Environmental Review Team Report

Northam Hills
Hebron, Connecticut

February 1979

ENVIRONMENTAL REVIEW TEAM REPORT
ON
NORTHAM HILLS, SECTION 4
HEBRON, CONNECTICUT

Preliminary Subdivision Plan

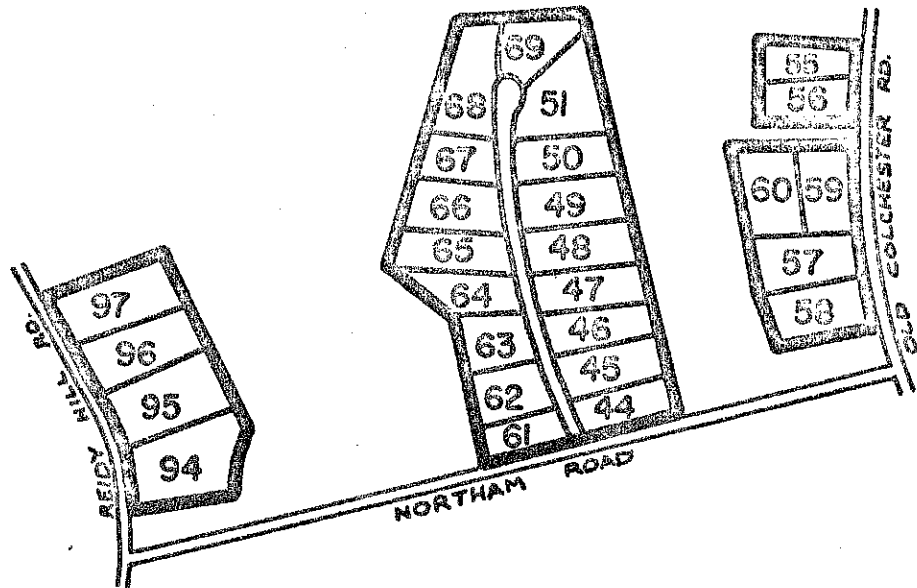
After examining preliminary and revised soils and topography data for Section 4 and during the actual field review, it is apparent that the location of septic systems will be a problem on this site. Soils range from shallow-to-bedrock types to those types with seasonally high water tables. These placement problems can be alleviated by careful engineering and construction of these systems, but such engineering measures should be in place and shown to be working before final approval on questionable lots.

Those lots containing highly erosive soils should have individual sediment and erosion control measures prepared and included on the plans before final approval of these lots. These measures should be implemented before construction begins on each specific lot. Consideration should also be given to connection of the interior access road passing through Section 4 to Old Colchester Road, thereby eliminating a single access/egress point for 17 lots. Also, completion of the total subdivision proposal may cause the need for an upgrading of Old Colchester Road and Reidy Hill Road due to increased traffic demands.

Lots 44, 45, and 46 are situated on Hollis soils. Sometimes the shallow-to-bedrock Hollis soil is variable, with deep pockets of soil present over the bedrock. Placement of on-site septic systems under these conditions is usually possible if these pockets can be located.

Lots 44 - 50 drain toward the proposed road. Construction of a grassed swale along the east side of the road would collect surface runoff from these lots. The swale allows for some natural infiltration. Appropriate measures to convey this water under driveways would be needed. A provision for drainage through lot 69 as proposed in the plan would be necessary. This swale system could tie into the road drainage system utilizing the riprap outlet.

Soils in Lot 94 along Reidy Hill Road include Peat and Muck, a wetland soil. By placing the driveway along the northern boundary, crossing the wetland may be avoided. Approximately half of the lot is on Gloucester soil and appears suitable for home development.
